DUKE POWER COMPANY

Subject: McGuire Nuclear Station
Docket Nos. 50-369 and 50-370
McGuire 1/Cycle 4 OFA Reload

ATTACHMENT 1

PROPOSED McGUIRE UNIT 1 AND 2 TECHNICAL SPECIFICATION CHANGES

FIGURE 3.1-0
MODERATOR TEMPERATURE COEFFICIENT VS POWER LEVEL

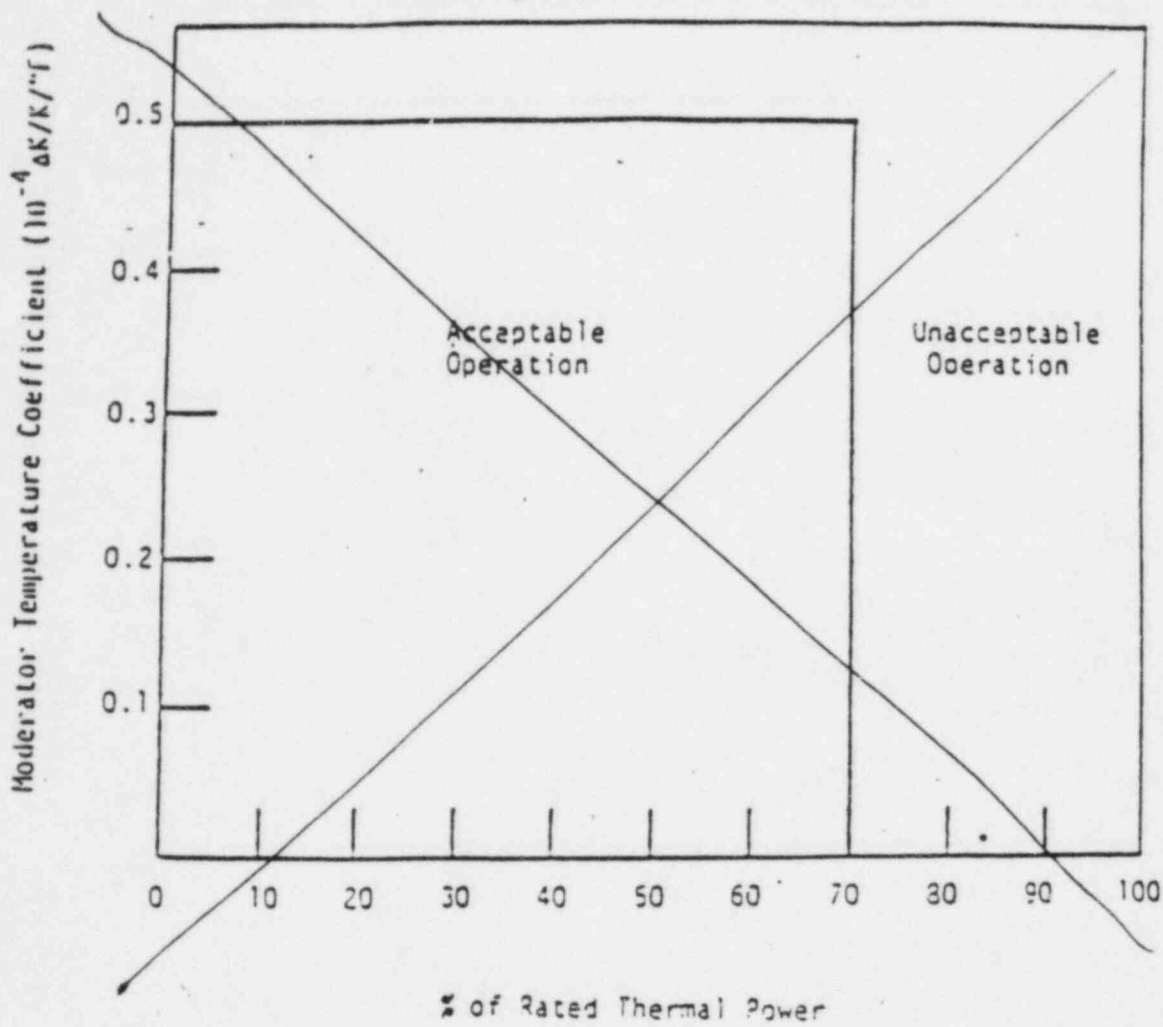
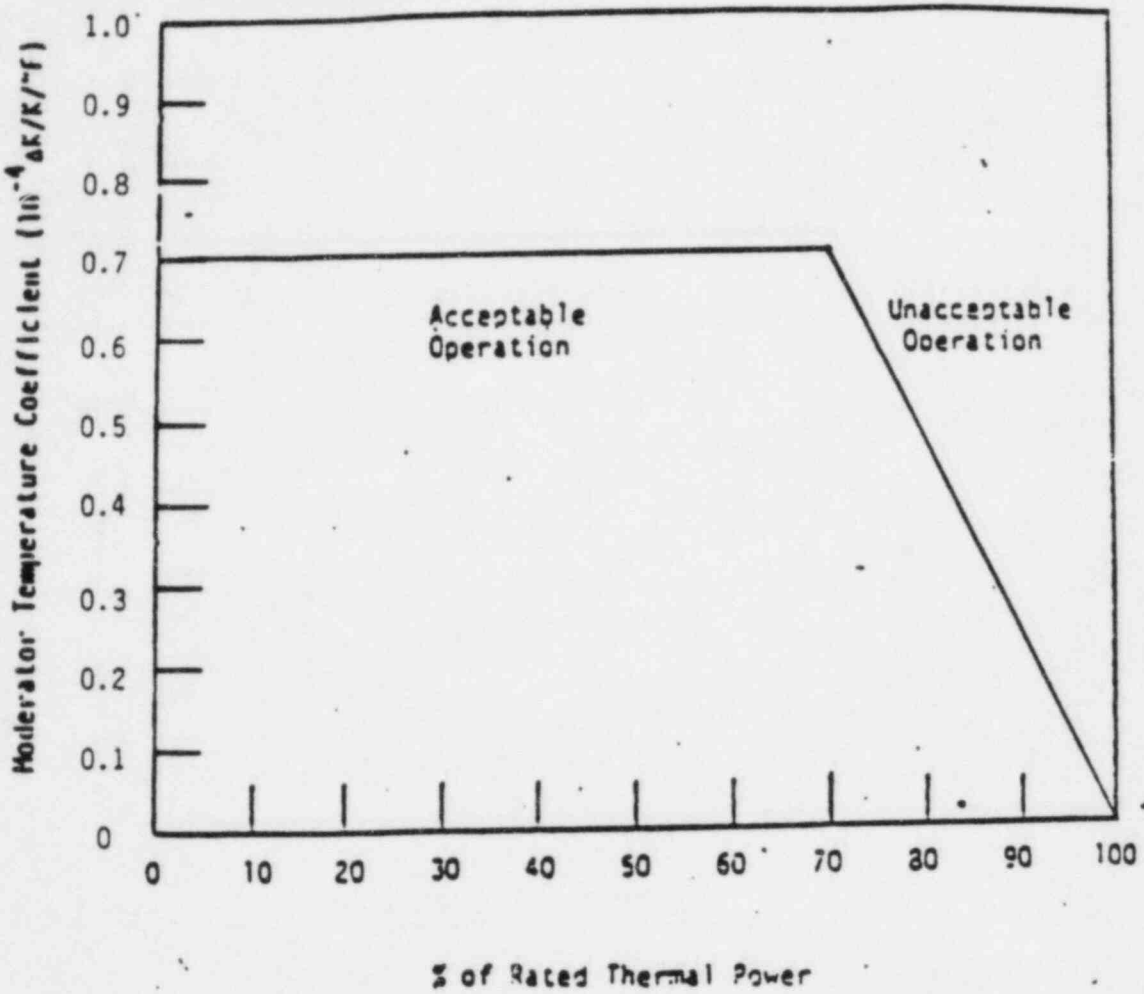
- a. Less positive than the limits shown in Figure 3.1-0, and
- b. Less negative than -4.1×10^{-4} delta k/k/°F for the all rods withdrawn, end of cycle life (EOL), RATED THERMAL POWER condition.

REPLACE WITH THE FOLLOWING
FIGURE (X)

FIGURE 3.2-1a
AFD Limits as a Function of Rated Thermal Power (4N111)
~~McGuire Unit 1 Cycle 4~~

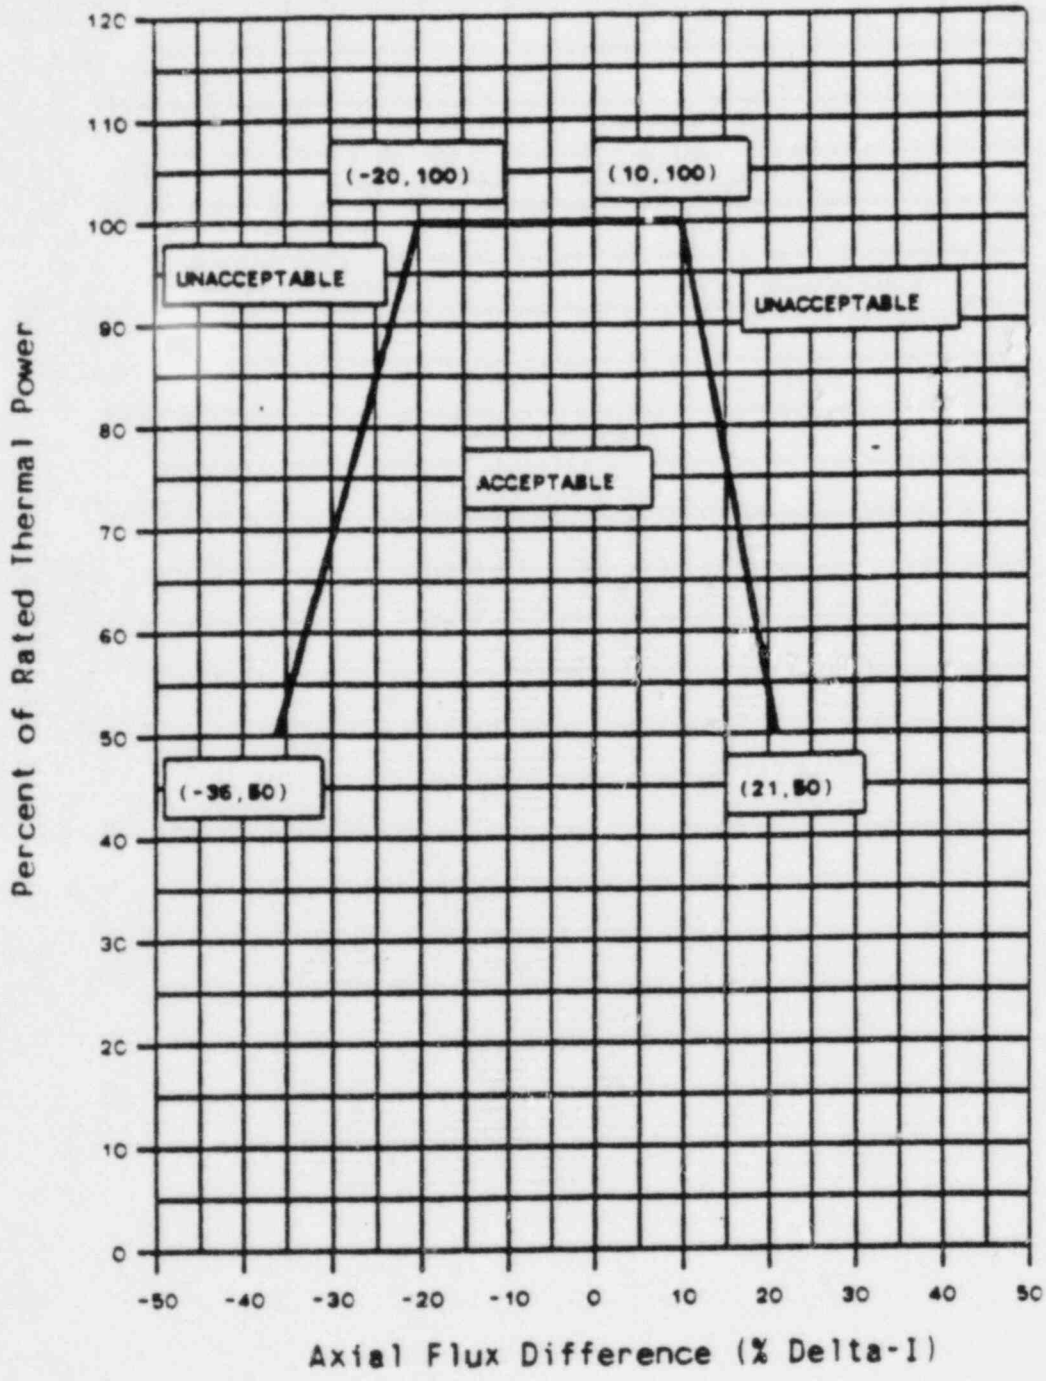
- a. the allowed operational space defined by Figure 3.2-1 for RAOC operation, or
- b. within a ± 5 percent target band about the target flux difference during base load operation.

INSERT THE FOLLOWING FIGURE (Y)

FIGURE 3.1-0
 MODERATOR TEMPERATURE COEFFICIENT VS POWER LEVEL

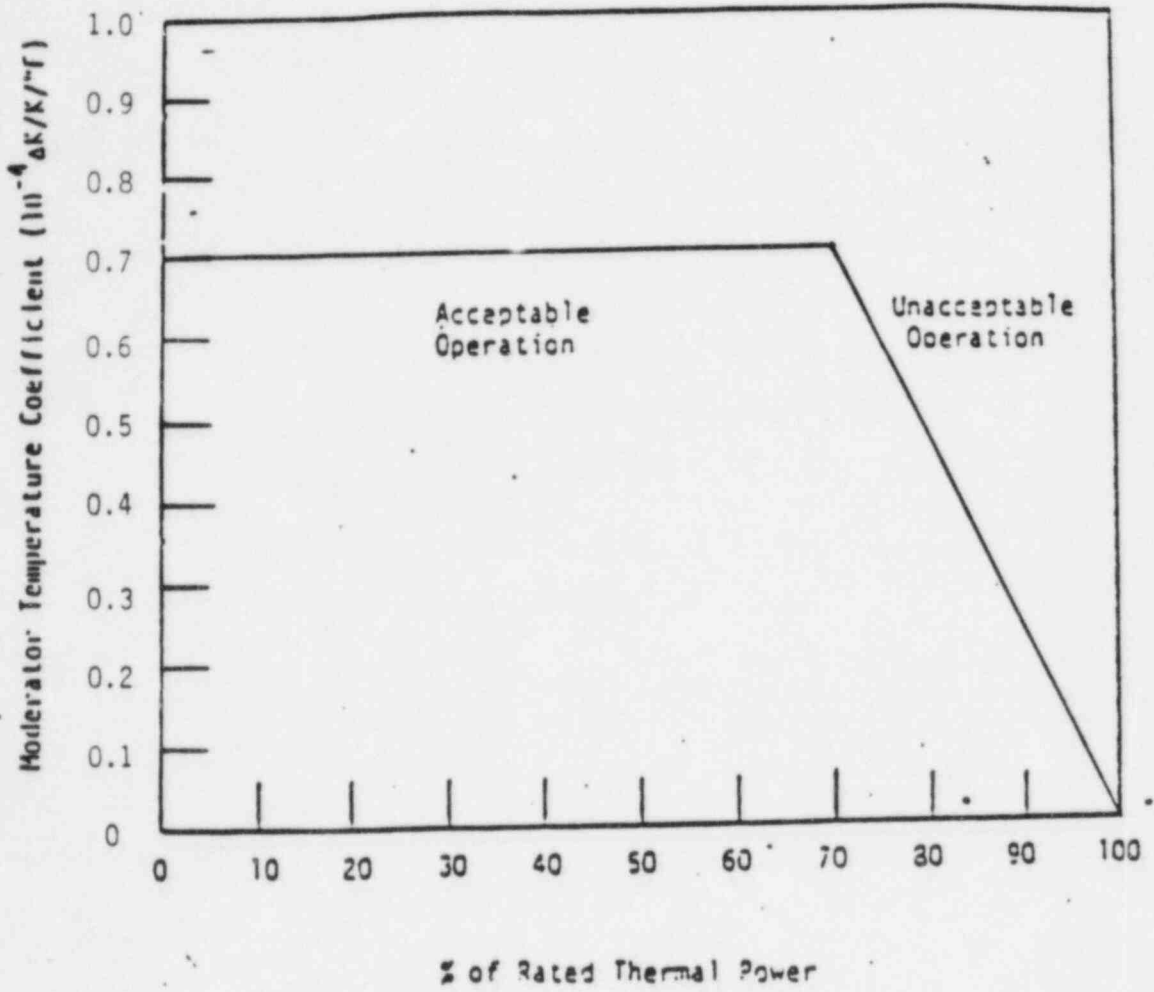
- a. Less positive than the limits shown in Figure 3.1-0, and
- b. Less negative than -4.1×10^{-4} delta k/k/ $^{\circ}$ F for the all rods withdrawn, end of cycle life (EOL), RATED THERMAL POWER condition.

FIGURE 3.2-1
 AFD Limits as a Function of Rated Thermal Power
 McGuire Unit 1 Cycle 4

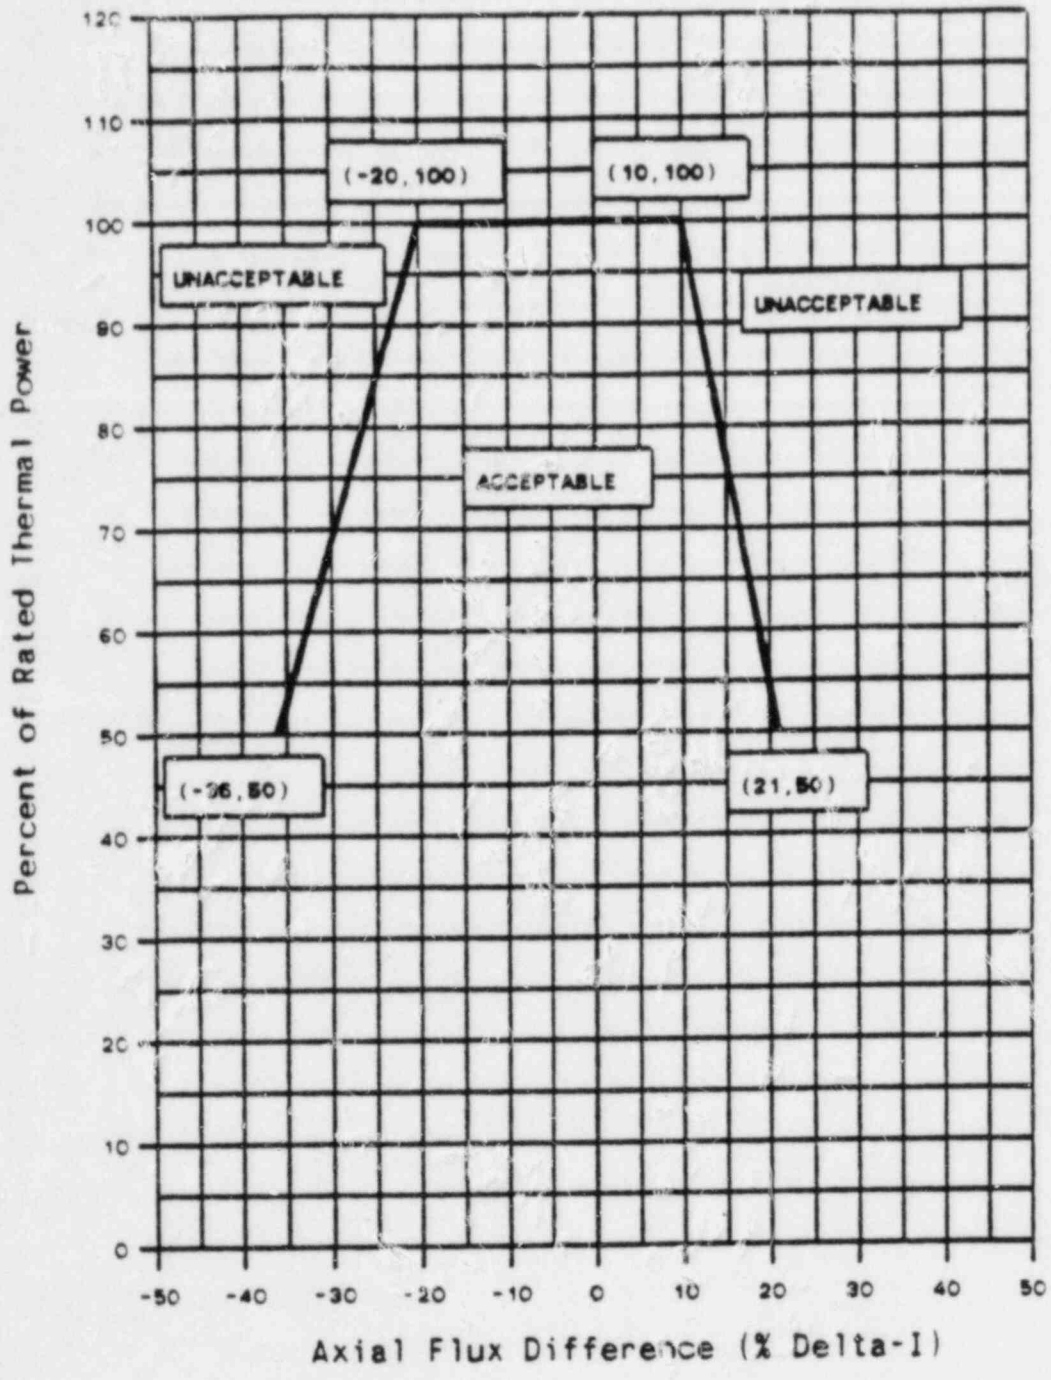
To ensure plant operation consistent with the design and safety evaluation conclusion statements made in the Cycle 4 RSE and to ensure that these conclusions remain valid, Technical Specification changes will be needed for Cycle 4 to incorporate RAOC and a positive moderator temperature coefficient. These changes (presented in Appendix A of the cycle-specific RSE) are discussed in the cycle-specific RSE, along with any necessary justifications. The McGuire Unit 1 Cycle 4 reload design has been performed assuming an increase in the low power beginning of cycle moderator temperature coefficient (MTC) to +7 pcm/degrees F (the MTC technical specification limit is raised to +7 pcm/degrees F up to 70% rated thermal power and ramped to 0 pcm/degrees F at 100% RTP). The unit could startup and operate with the currently approved Technical Specification limit (a "step" of +5 to 0 pcm/degrees F at 70% power) but the probability of entering the action statement requiring interim rod position limits and potential delays in the cycle startup process and a special report to the Commission would be increased. Attachment 2B is the safety evaluation report presenting the evaluations and analyses performed verifying the acceptability of operation of McGuire Unit 1 (and 2) with this increased positive MTC limit of +7 pcm/degrees F, including a description of the proposed change's impact on the FSAR Chapter 15 transients (this report is identified as reference no. 10 in the McGuire Unit 1/Cycle 4 RSE). The McGuire FSAR will be revised accordingly in the appropriate annual FSAR update following approval of this change. The revised Unit 1 RAOC envelope is based upon the F_Q limit of 2.26. The McGuire Unit 1 F_Q limit was increased from 2.15 to 2.26 in submittals associated with the Unit 1/Cycle 3 reload (and for Unit 2 with the Unit 2/Cycle 2 reload). However, the RAOC AFD envelope continued to be based upon the 2.15 F_Q limit until this cycle's RAOC analysis, although the envelope could have been expanded along with the previous limit increase. The revision to the Unit 1 RAOC AFD envelope is simply taking credit for the previously approved higher F_Q limit and brings the nuclear design and LOCA analysis assumption into agreement (Note: Although credit for the 2.26 F_Q limit currently in effect on Unit 2 has not been taken in Unit 2 RAOC analyses performed to date (including the recent Unit 2/Cycle 3 analysis as reflected in the Tucker to Denton letter of February 21, 1986), Duke anticipates similarly expanding

Figure 1

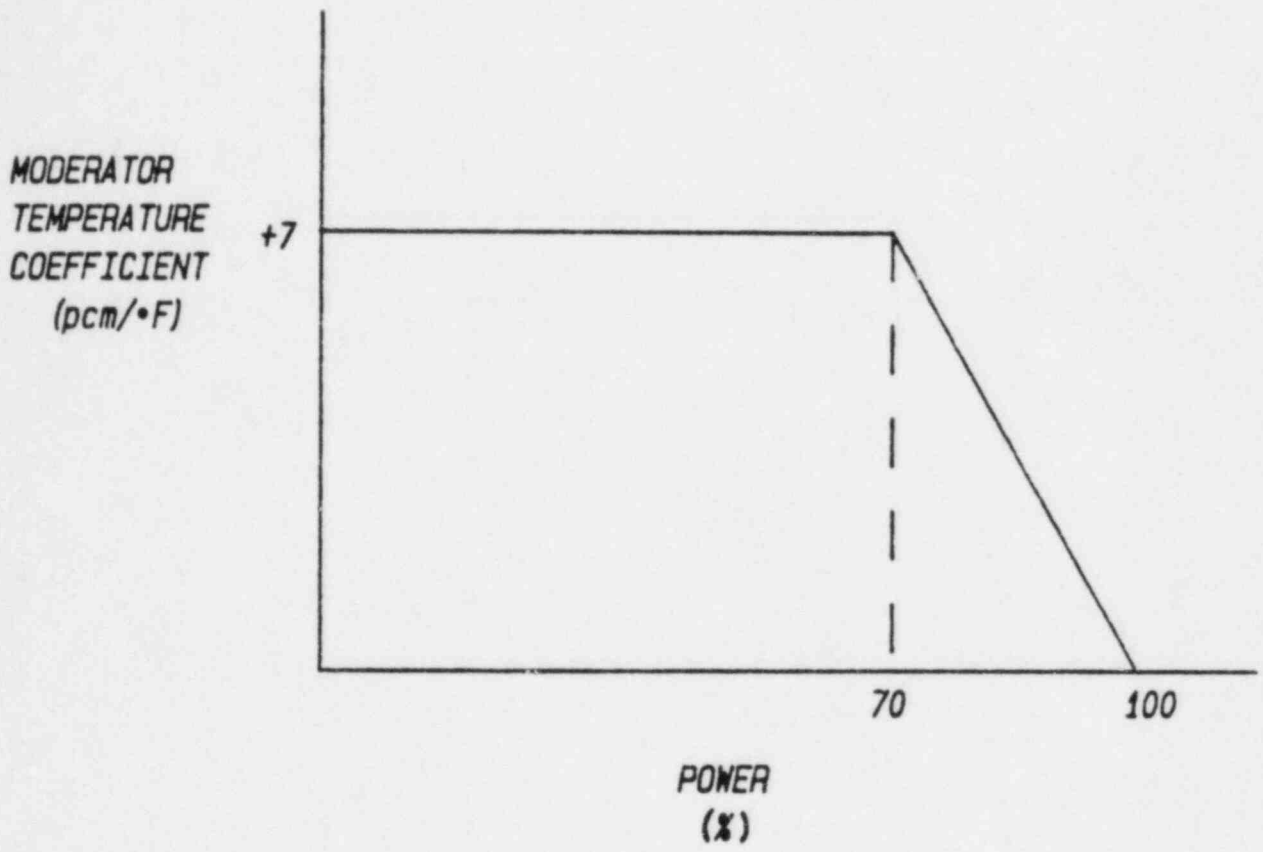
The proposed Technical Specification change would allow a +7 pcm/°F MTC below 70 percent of rated power, ramping down to 0 pcm/°F at 100 percent power. This MTC is diagrammed in Figure 1. A power-level dependent MTC was chosen to minimize the effect of the specification on postulated accidents at high power levels. Moreover, as the power level is raised, the average core water temperature becomes higher as allowed by the programmed average temperature for the plant, tending to bring the moderator coefficient more negative. Also, the boron concentration can be reduced as xenon builds into the core. Thus, there is less need to allow a positive coefficient as full power is approached. As fuel burnup is achieved, boron is further reduced and the moderator coefficient will become negative over the entire operating power range.

Except as noted, the analyses employed a constant moderator coefficient of +7 pcm/°F, independent of power level. The results of this study are conservative for the accidents investigated at full power, since the proposed Technical Specification diagrammed in Figure 1 requires that the coefficient linearly decrease from +7 pcm/°F to 0 pcm/°F from 70 percent to 100 percent of rated power.
